Technical Specification Change to APRM Setpoints

Technical Specification Change concerning duration of Integrated Primary Containment Leak Rate Test (ILRT)

Technical Specification Change RE: T. S. 3.6.1

ADMINISTRATIVE TECHNICAL SPECIFICATION CHANGE

FIGURE 1 STATION ORGANIZATION
 FIGURE 8.2.2

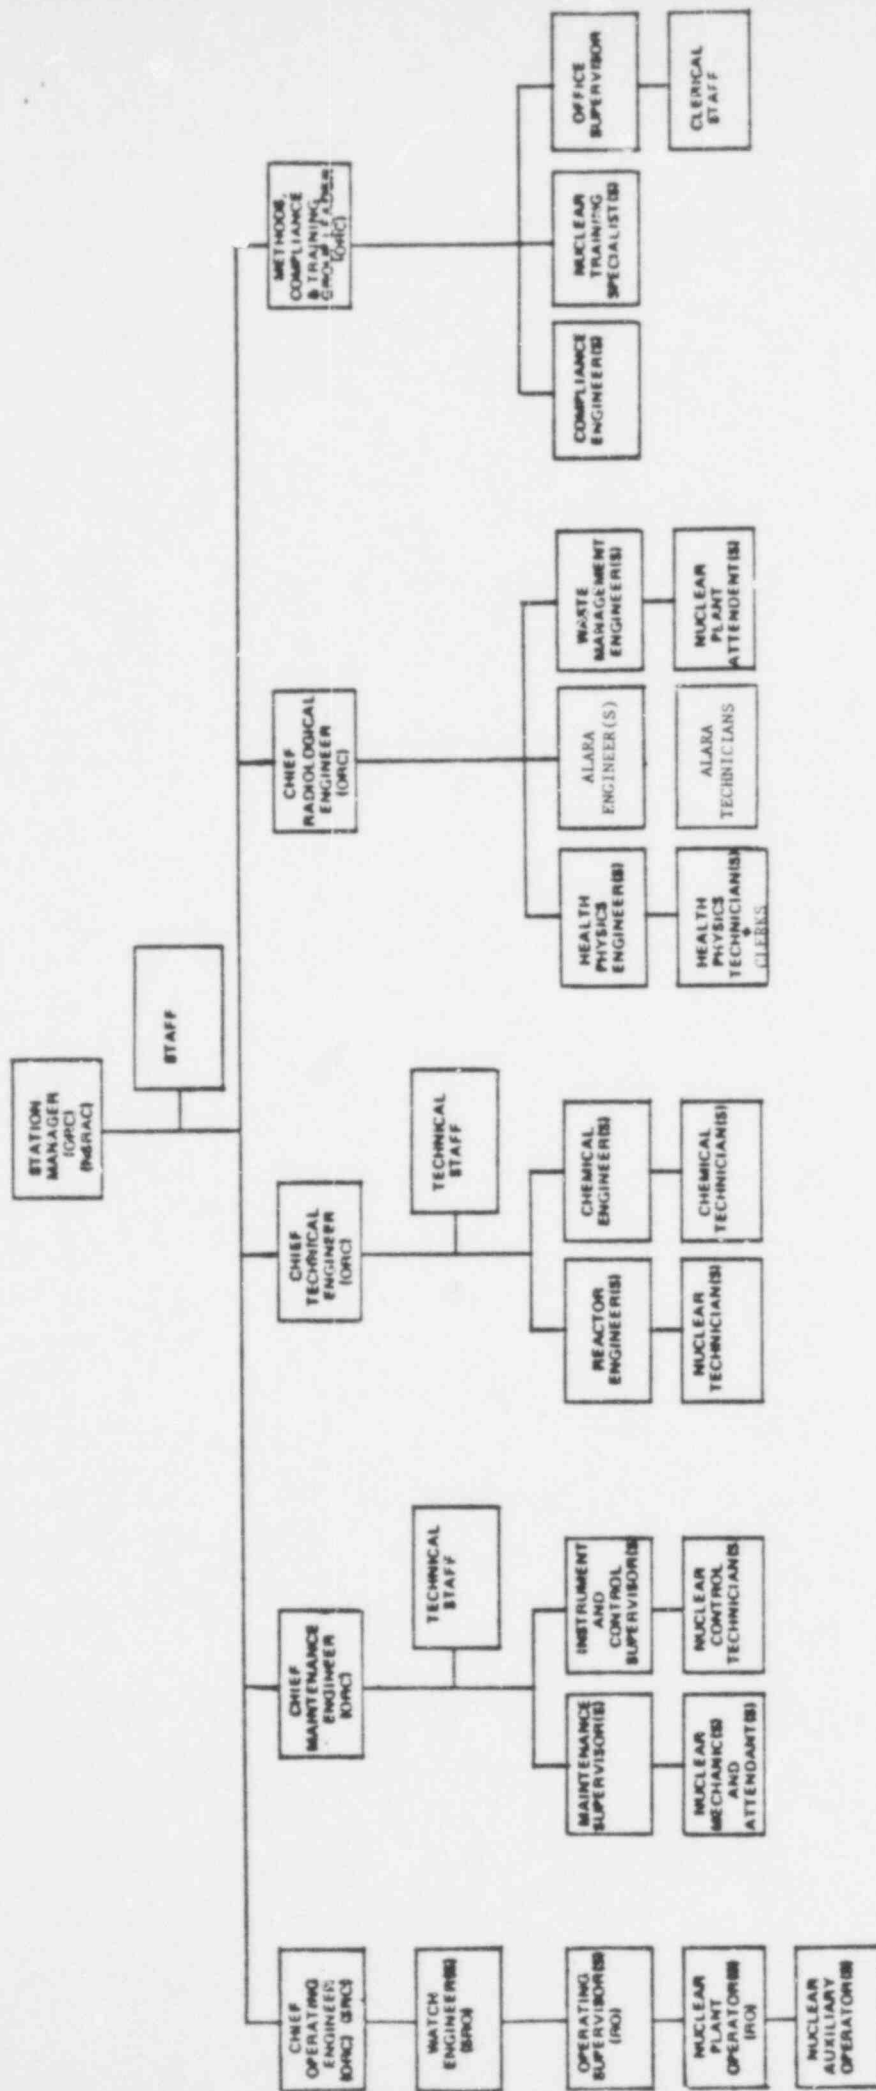
Reference is made to Pilgrim Nuclear Power Station - Unit #1 Technical Specification Appendix A, Section 6, Figure 6.2.2, titled "Pilgrim #1 Station Organization". The changes would consist of restructuring the chart (Exhibit A) to accommodate organizational changes at the Station. Also, Section 6.5.A.2 "ORC Composition" will be updated to reflect another ORC member.

Recently, Boston Edison Company has initiated changes to improve the Health Physics Program at Pilgrim and as a result new positions have been created. The subject positions are titled as follows:

Prior to the creation of the Chief Radiological Engineer the Health Physics Program was under the responsibility of the Chief Technical Engineer. It is Boston Edison's intention, by means of these new positions, to increase Station management's attention toward the Health Physics Program.
